802.3CG CONSISTENT PMA ELECTRICAL PARAMETERS AND LINK SEGMENT DEF

Geneva, Jan 22nd 2018

802.3cg Short-Reach PHY

PMA Electrical Parameters and Link Segment Definition

Eye Diagrams – Case A (MC=43dB,20MHz; $A_{TX}=400\text{mVpp}$)

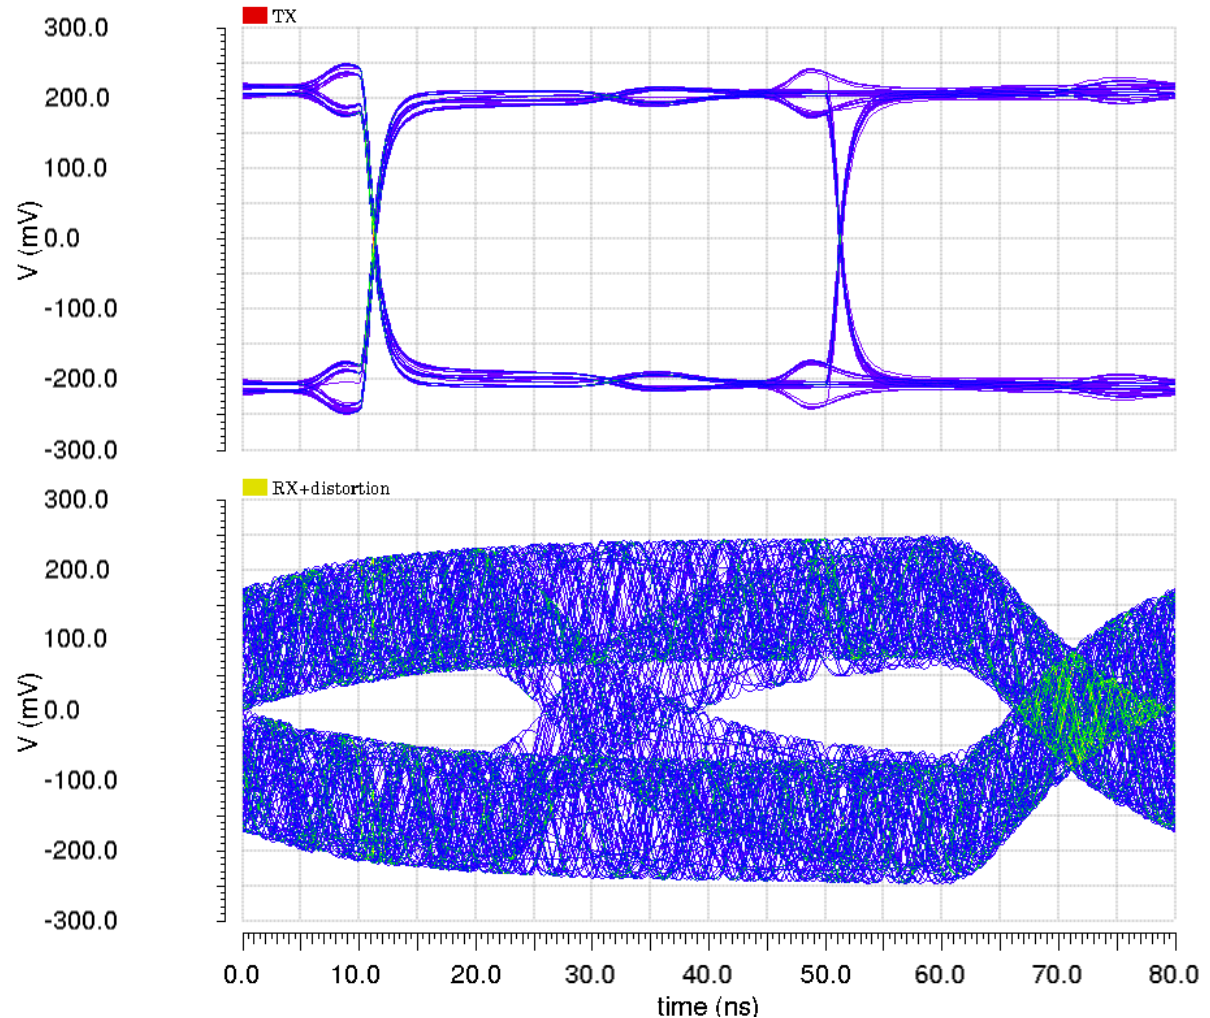
- Transmit eye diagram
- Receive eye diagram
=> BCI severity IV (3-200MHz)
attenuated by mode conversion added
- LowPass 1st order
-3dB@25MHz in RX

Eye Diagrams – Case B (MC=40dB, 12MHz; $A_{TX}=280\text{mVpp}$)

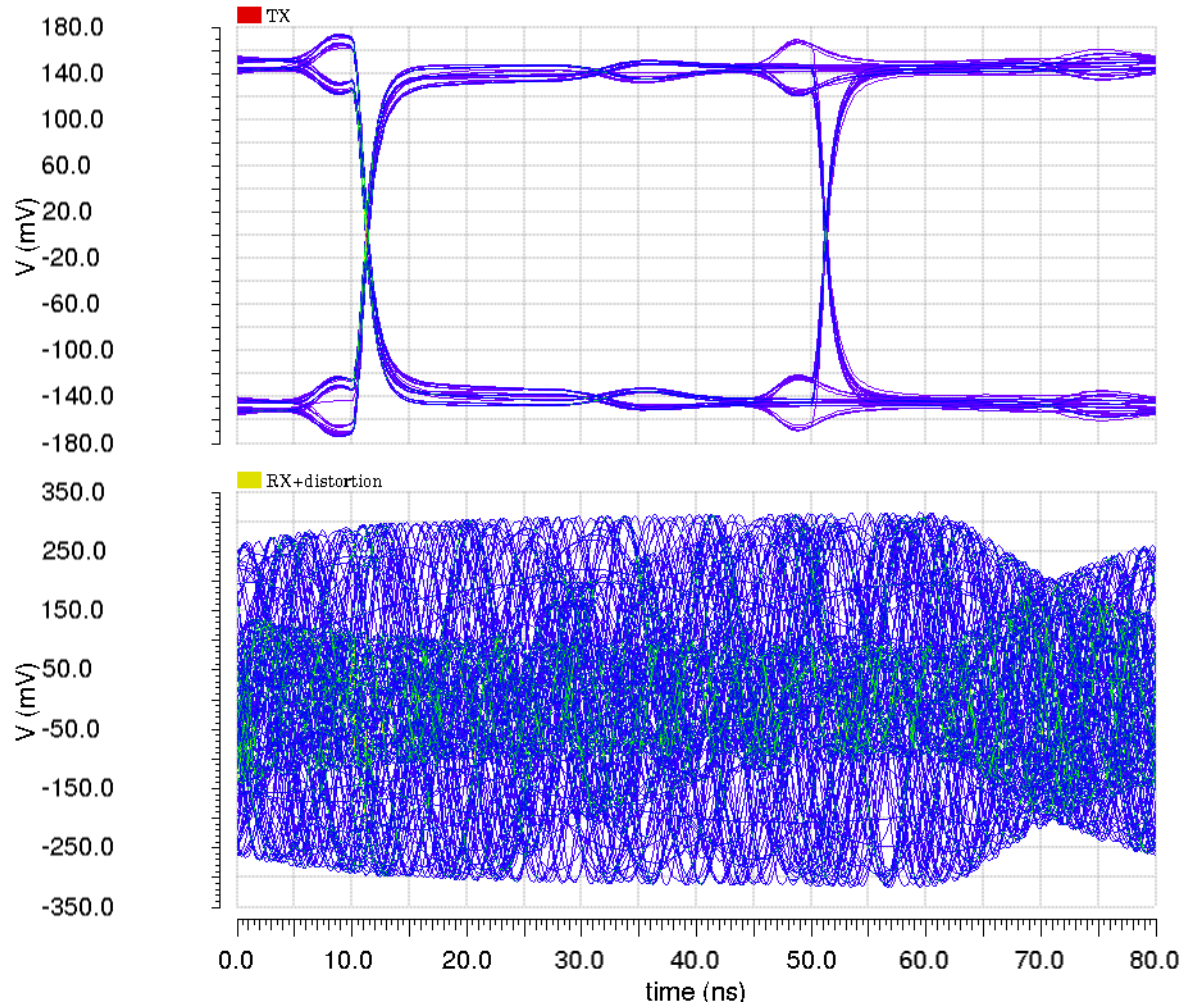
- Transmit eye diagram
- Receive eye diagram
=> BCI severity IV (3-200MHz)
attenuated by mode conversion added
- LowPass 1st order
-3dB@25MHz in RX
